Illinois Department of Transportation

SUBJECT: MidAmerica St. Louis Airport
Mascoutah, Illinois
St. Clair County
Illinois Project Number: BLV-5101
AIP Project Number: 3-17-0146-TBD
Contract No. SC071
Item No. 02A, April 26, 2024 Letting
Addendum A

NOTICE TO PROSPECTIVE BIDDERS

ADDENDUM A PLAN SHEET REVISIONS

EROSION CONTROL PLAN 1

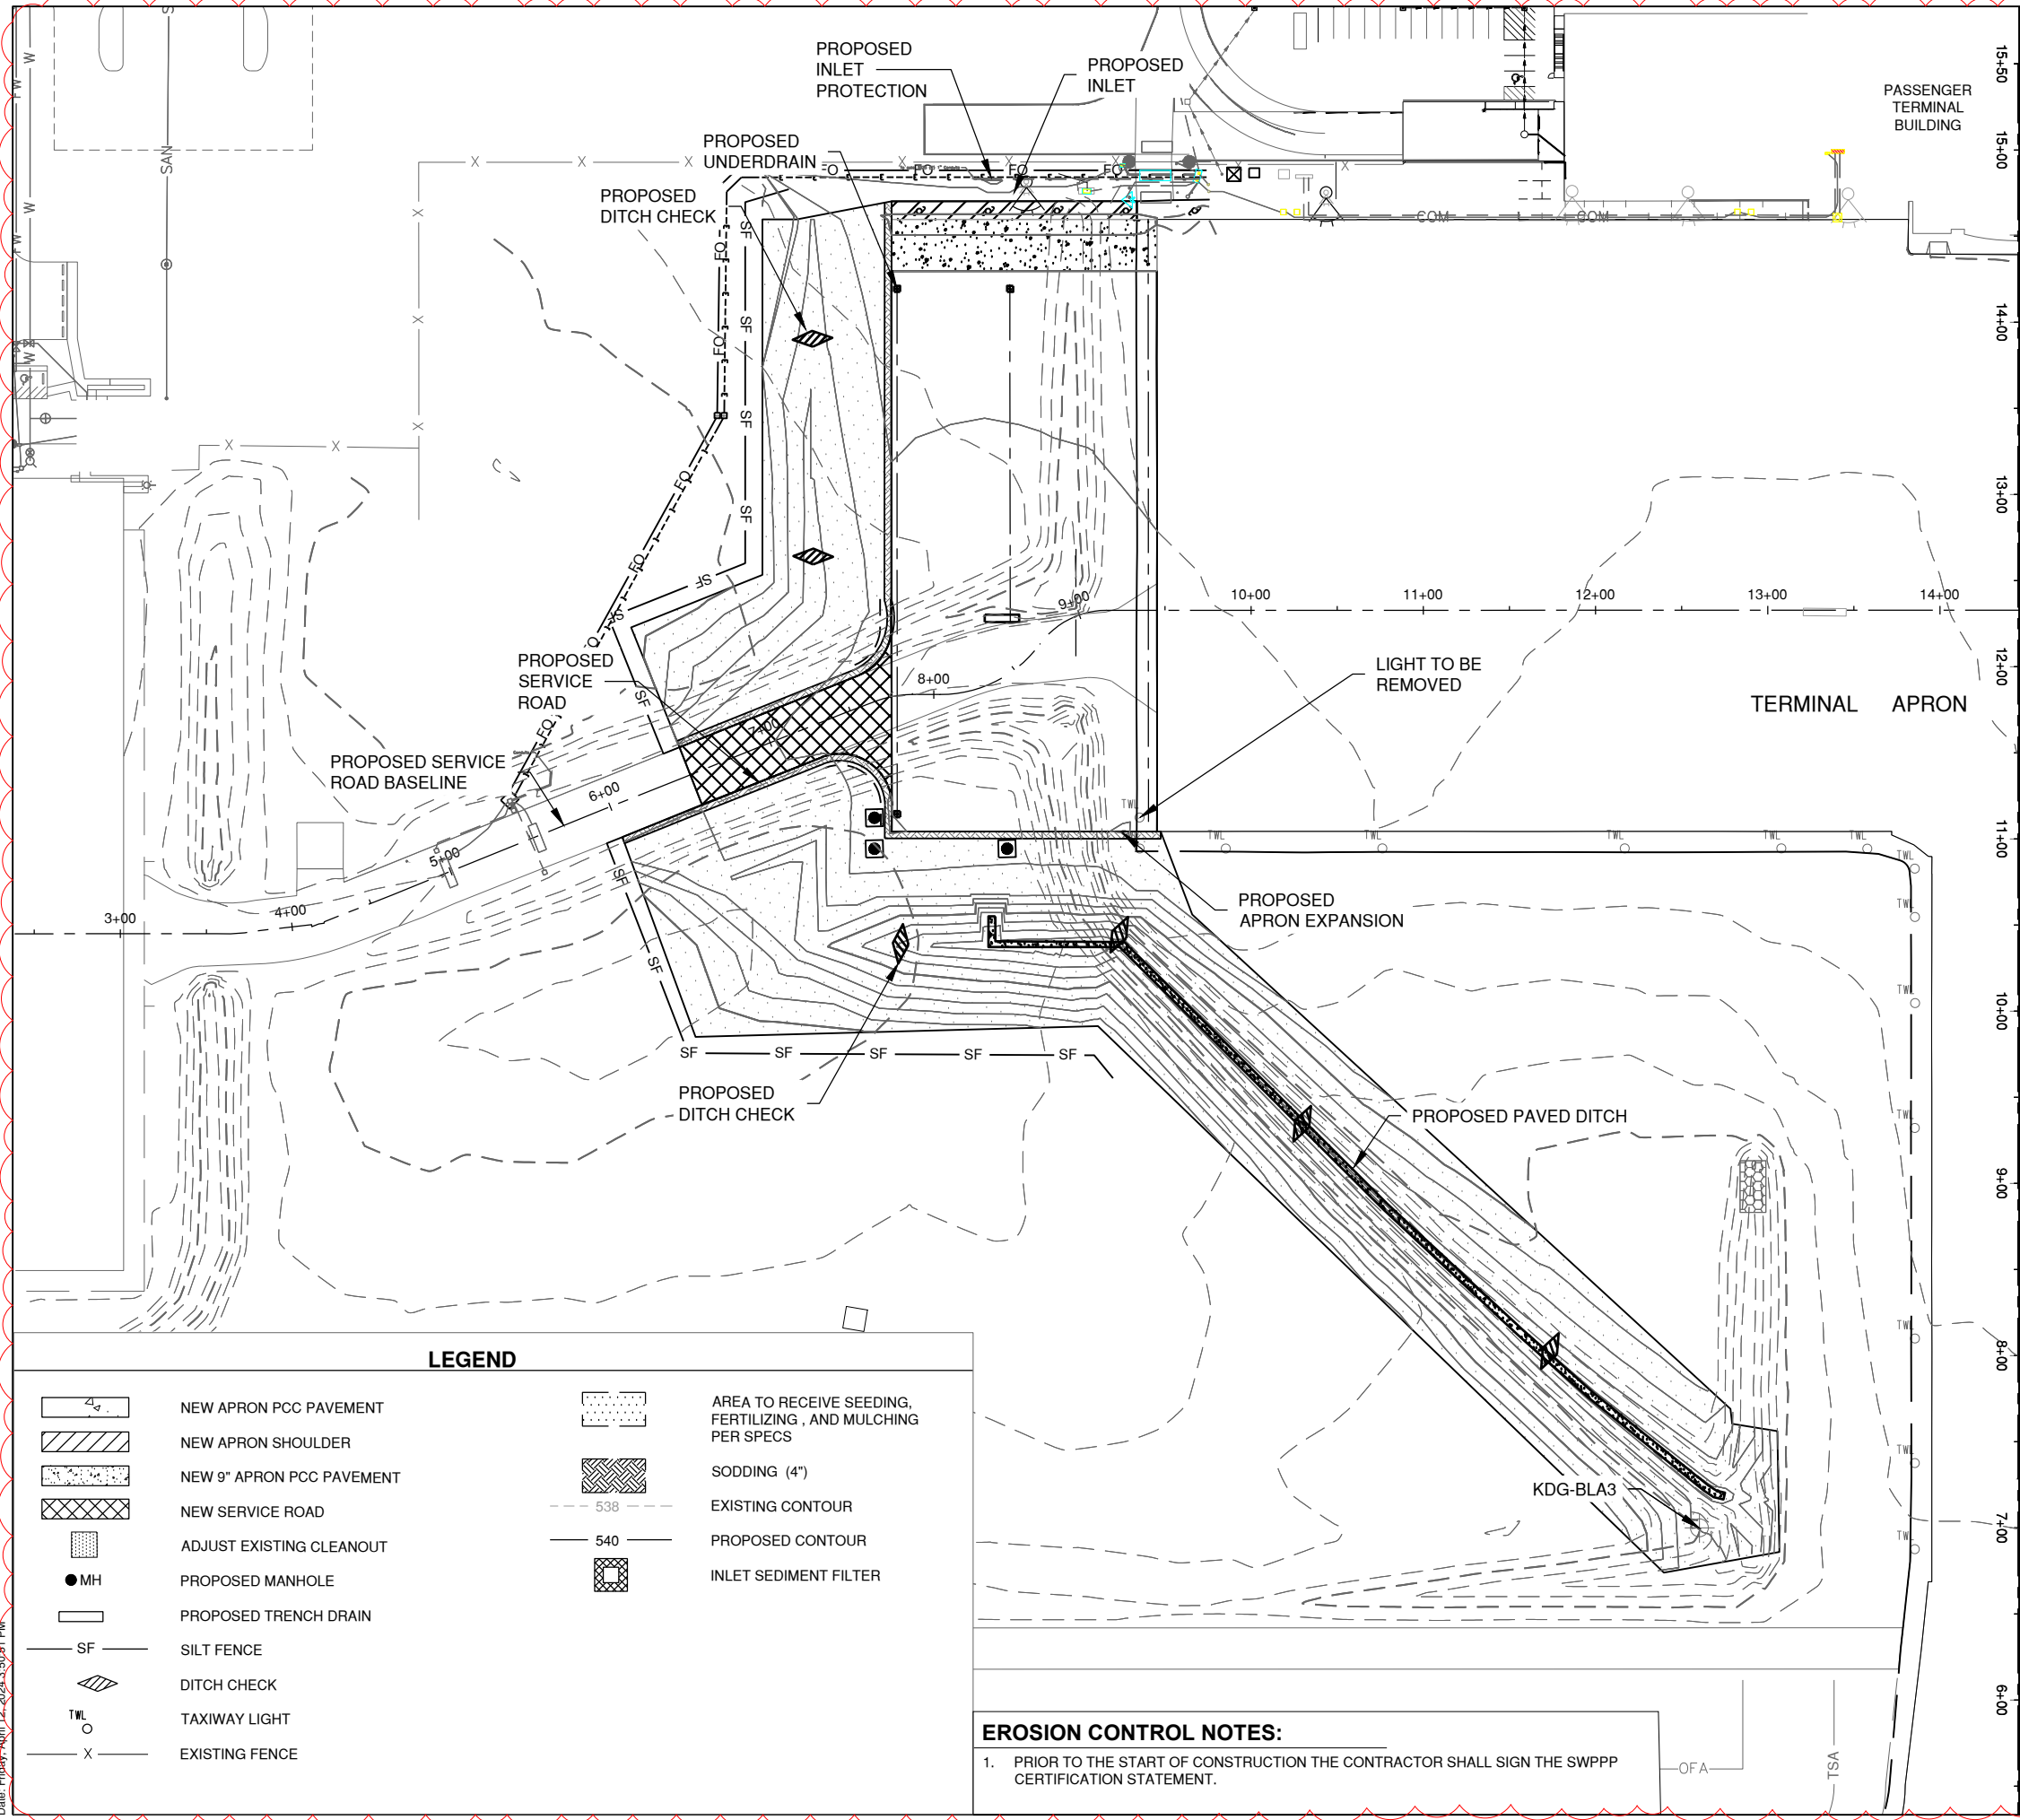
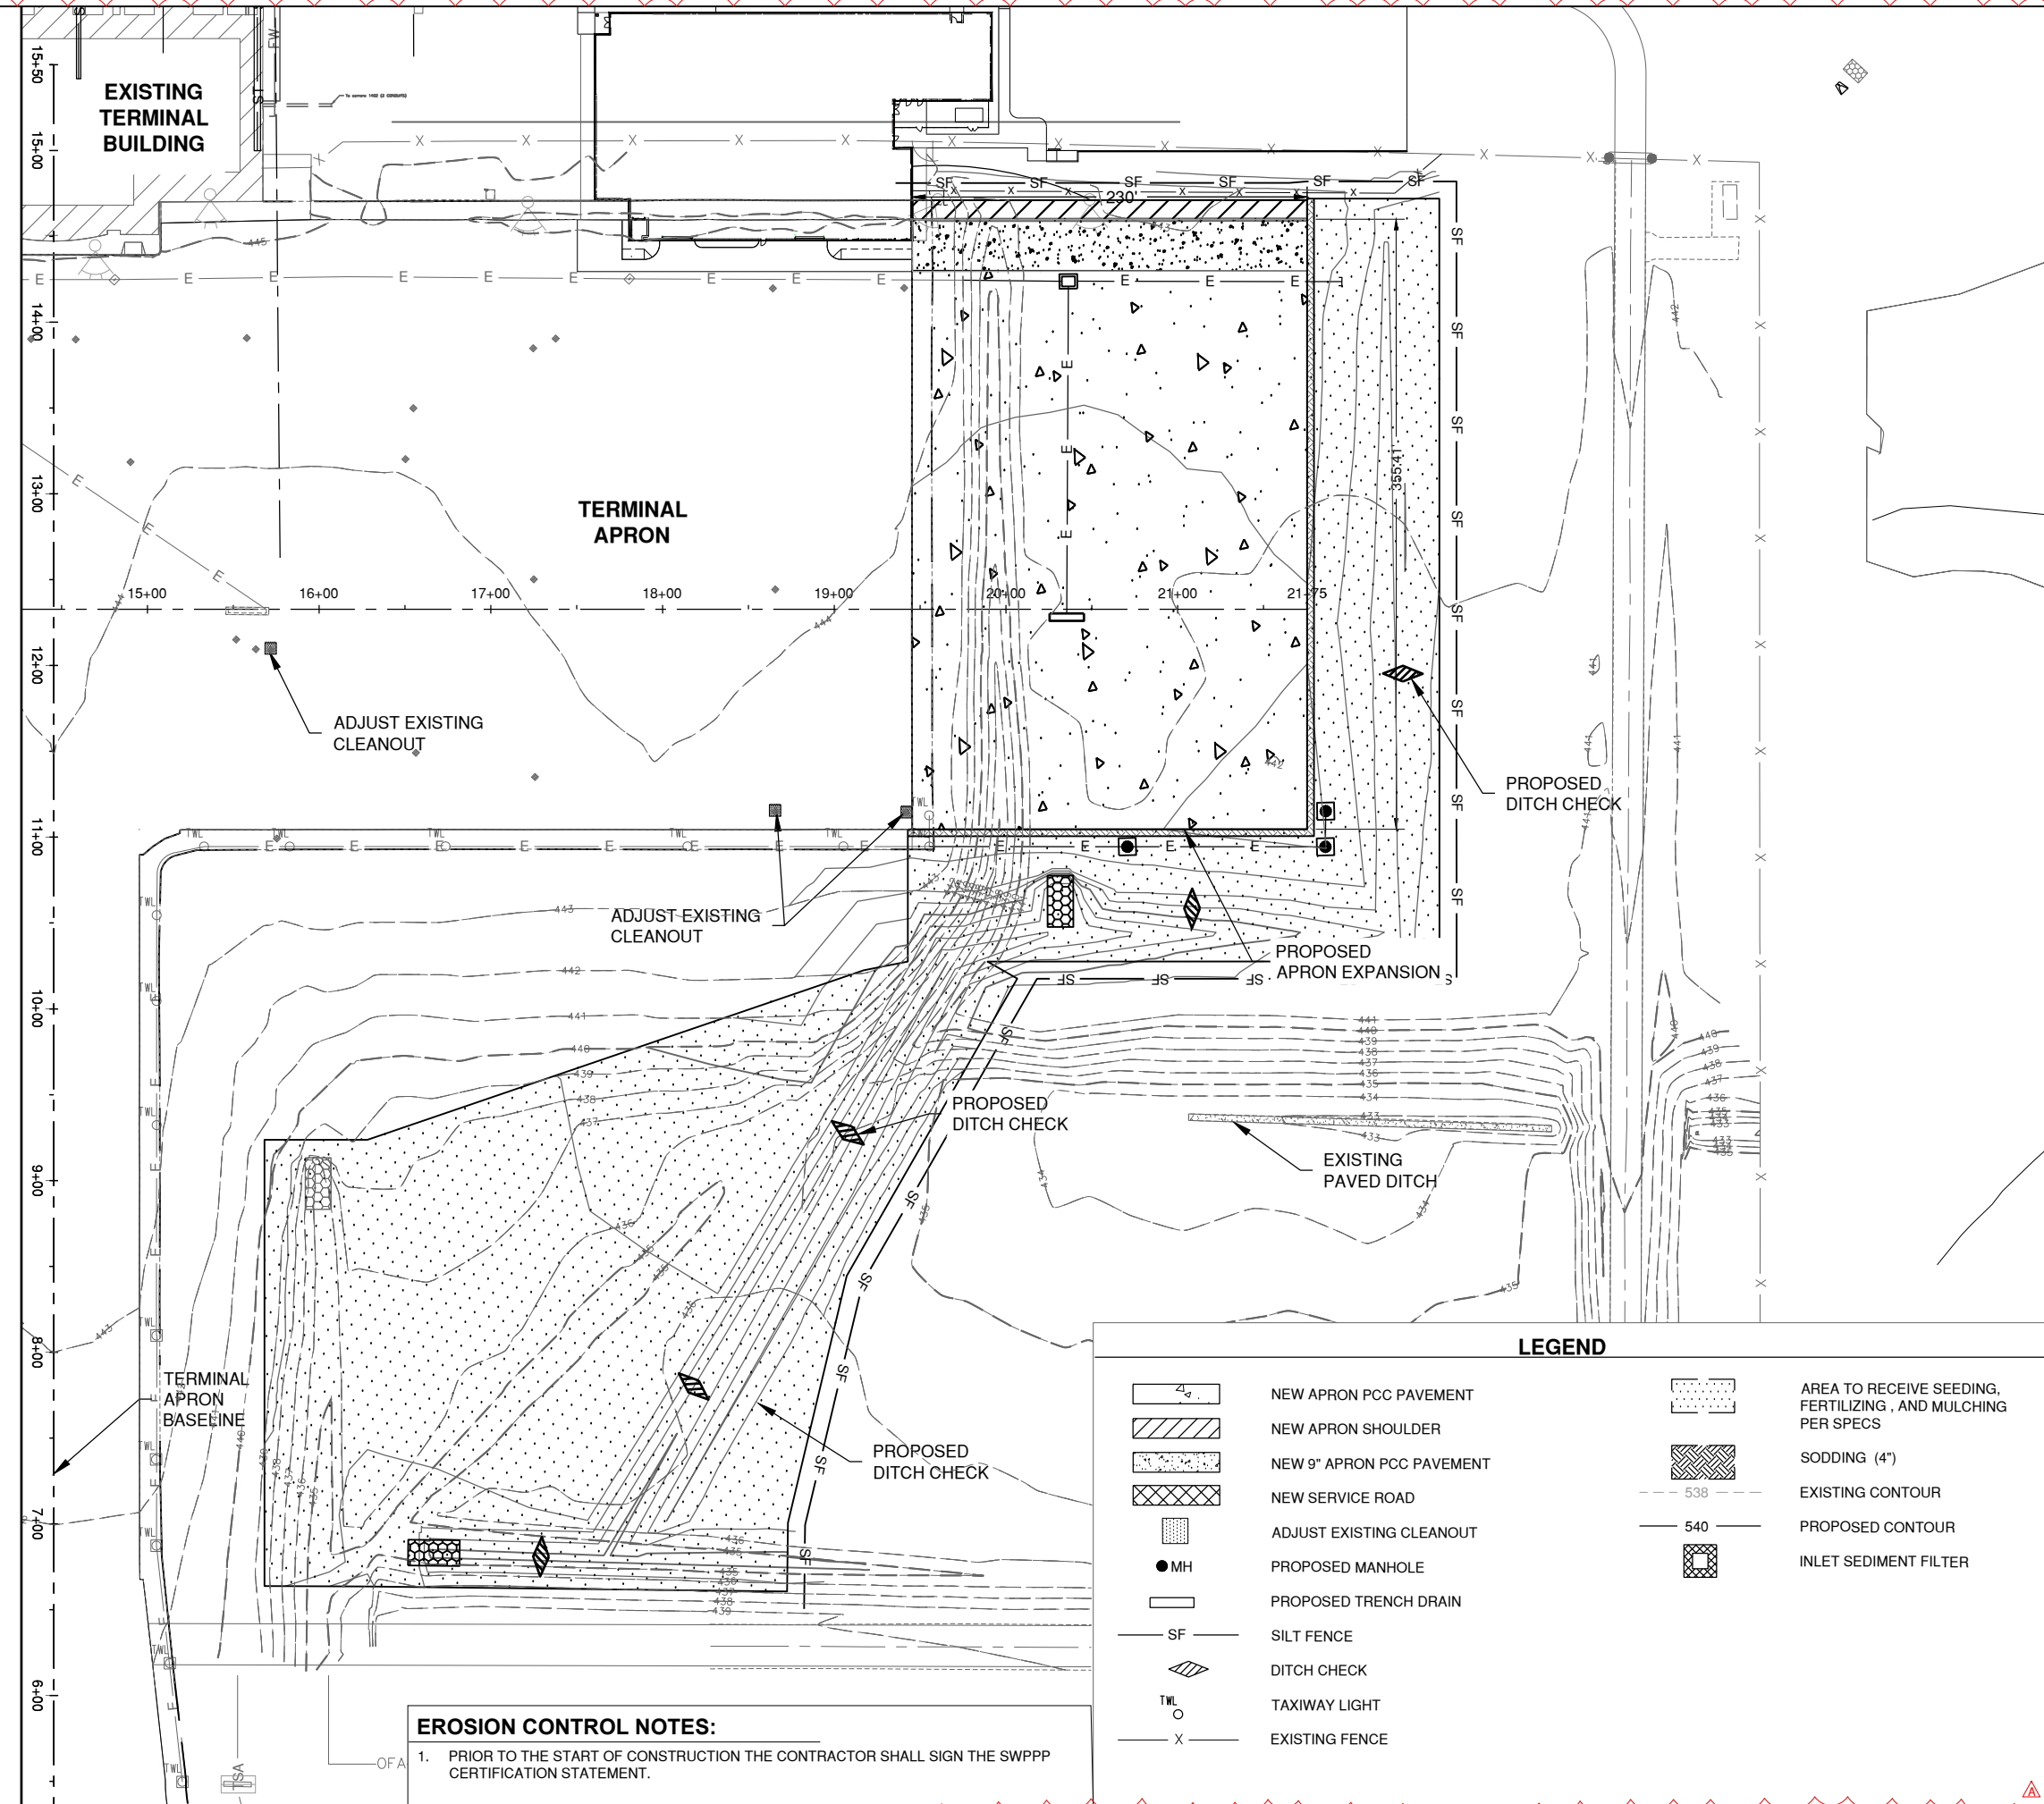
- Updated to cleanup and delete unnecessary linework
- Sheet LG102
 - Updated to cleanup and delete unnecessary linework
- Sheet CD101
 - Updated to add existing features, remove unnecessary linework and clarify symbols on sheet
